**UPDATED** ALTERATION TO A HISTORIC PROPERTY STAFF REPORT

**Site / District(s):** 9-11 Aldersey Street / LHD  
**Case:** HPC 2013.085  
**Applicant Name:** Gerard Meeham, Trustee for G&T Realty Trust  
**Applicant Address:** 19 Ames Avenue, Canton, MA 01757

**Date of Application:** 10/31/2013  
**Legal Notice:** *Restore and alter the existing historic structure; construct two additional residential structures.*  
**Recommendation:** Certificate of Appropriateness to alter/restore the existing historic structure; and Deny Certificate of Appropriateness for two additional structures  
**Public Hearing(s):** 11/19/2013, 1/21/2014

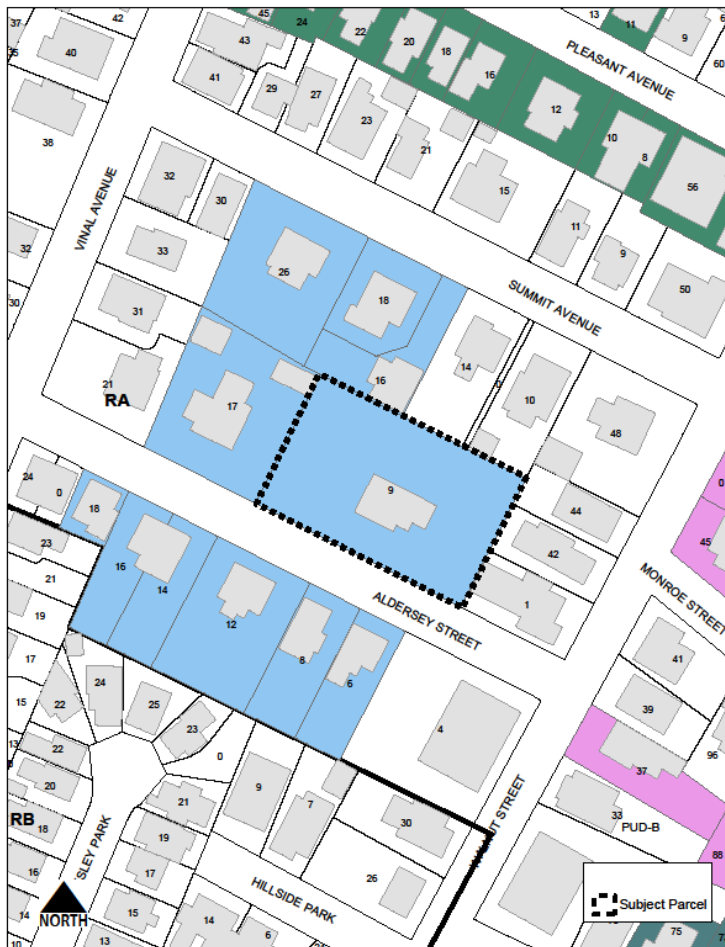
The site plan illustrates that the walkway to the historic structure would change from being located at the side of the porch **to an additional walkway at** the center of the porch. As this

would modify access to the building, research should be done to determine if the porch may have had a center entry at one point. Placement of the front door on the center of the façade and the original Greek Revival style suggest that the original access may have been centered. However, as the current access is clearly from the side of the porch, one solution would be to add the center access yet maintain the side access. **The updated submission maintains the side entrance and proposes to add the centered walkway.**

The addition of parking for ~~22~~ **12** vehicles and the amount of space devoted to vehicular movement would **still** significantly alter the circulation of the site. Staff recommends significantly reducing or even eliminating the surface parking as well as to remove one of two driveways in an effort to maintain as much existing open space on-site as possible. While any changes to the site will likely negatively affect the integrity of the site, and therefore the historic structure, reducing the on-site parking and hardscape minimizes the reduced integrity of the site and structure. **The updated submission maintains surface parking for 12 vehicles as well as two driveways.**
